Substantive response of the Local Highway Authority to a planning consultation received under The Development Management Order.

Planning Application Number: 24/00083/HYB

Application Address: Land At Burbage Fields Farm Bullfurlong Lane Burbage Leicestershire

Description of Application: Re-consultation. Hybrid planning application for 422 dwellings, public open space, associated infrastructure and the demolition of 65 and 65a Coventry Road, and Burbage Fields Farm and outline planning application for a residential care home and up to 11no. self-build plots (all matters reserved except for access)

Figure 1: Approximate priority junction provision on single carriageway roads based on flows only reproduced from Figure 2.3.1 of CD 123: Geometric design of at-grade priority and signal-controlled junctions

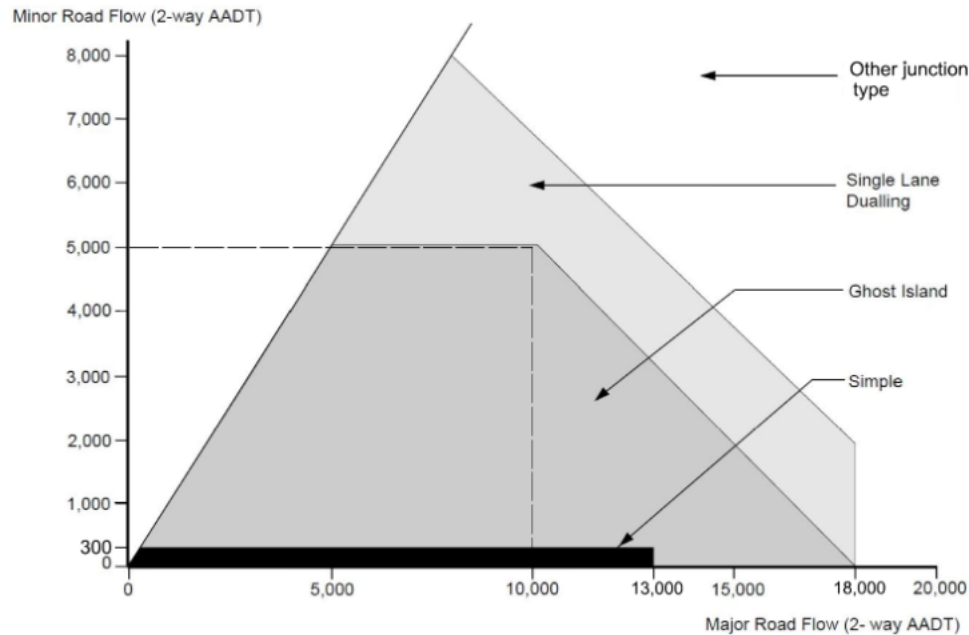
The applicant has quoted 400 two-way movements on Coventry Road in the AM-PM peaks, but Annual Average Daily Traffic (AADTs) are needed to use the chart in DMRB CD123 in Figure 1 below. The predicted trip generation figures seem to point to something more substantial than a simple junction being needed based on the AADT on Coventry Road which are presented in the traffic flow diagrams on the LPA website on 23 January 2024 and the likely AADT on the minor road which will serve the proposed development.

The applicant would need 8.5m for the carriageway (2.5m turning lane and 3m running lanes), plus a 2m footway. Following a review of the drawings which have been provided there would not be space to fit in this 10.5m total corridor width. Therefore the LHA would agree with the applicant that there would be insufficient room within the highway to fit in a ghost island right turn lane. However, the effect on pedestrians crossing on Coventry Road could be mitigated by providing traffic islands with tactile paving.

Notwithstanding this, the applicant is therefore required to consider the access proposals and submit revised proposals accordingly.
